Informal document GRVA-17-47
17th GRVA, 25-29 Sep. 2023
Provisional agenda item 8(a)

UN Regulation No. 140 modification proposal

GRVA-17, September, 2023

Does 270 ° amplitude give more information?

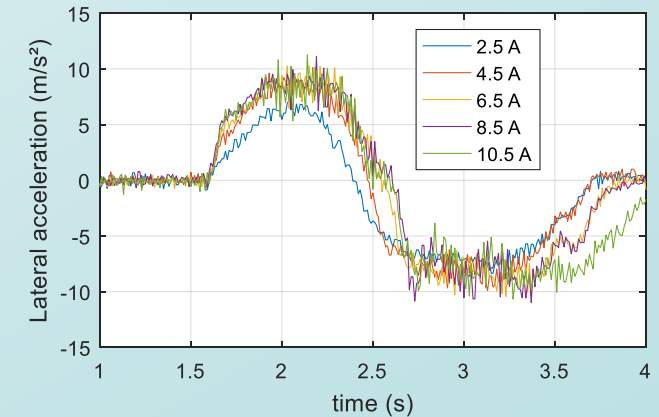
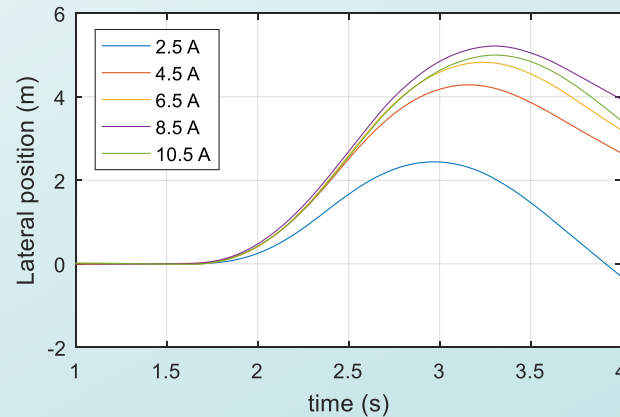
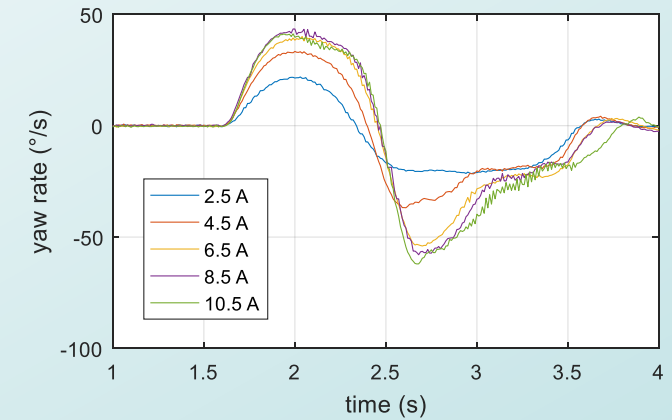
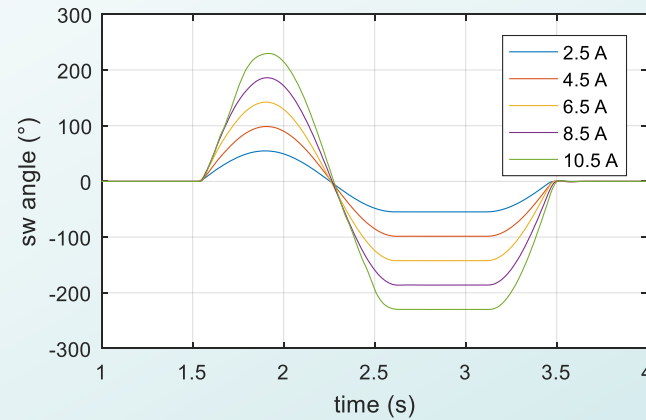
- On this example, above ~7 A, front tires are saturated so more steer don't give more force
- No benefit to go over ~7 A
- No modification of yaw rate and lateral acceleration after 7A run
